Building Work Rectification Order

Section 33 of the Residential Apartment Buildings (Compliance and Enforcement Powers) Act 2020

Bennett Hilly Development Pty Ltd (ACN 165 271 303) is being given this Building Work Rectification Order (Order) in relation to addresses 1 Northcote Street (SP 95581), MORTLAKE NSW 2137 and 14-22 Hilly Street (SP 95582), MORTLAKE NSW 2137 (the Development).

Table 3 – Basis of reasonable belief as to serious defects

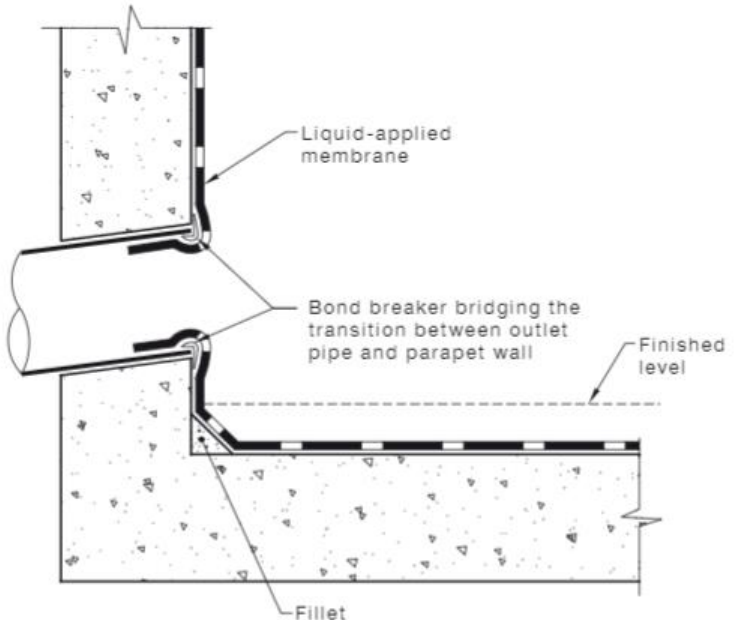
Serious Defect Ref No.	Building element in which serious defect has been identified	Defect	Reason why defect is a serious defect	Applicable approved plan, Code or Australian Standard	Consequences of serious defect
1.	Fire safety system	Fire hydrant not installed at required height	Fire hydrants must be easily accessible to fires services during case of fire	The installation of the fire hydrant at the incorrect height demonstrates a failure to comply with Australian Standard 2419.1 2005 Fire Hydrant Installations Part 1: System design, installation and commissioning. Section 3 Locations and Other Provisions, Clause 3.2 Location of On-Site Fire Hydrants, Clause 3.2.2.1 which refers to Figure 3.2.2.1 states:	During a fire, the improper height may delay or impede fire brigade activities.

<p><i>“The centre line of the fire hydrant valve or outlet not less than 750mm and not more than 1200mm above the ground, finished floor level or platform.”</i></p>
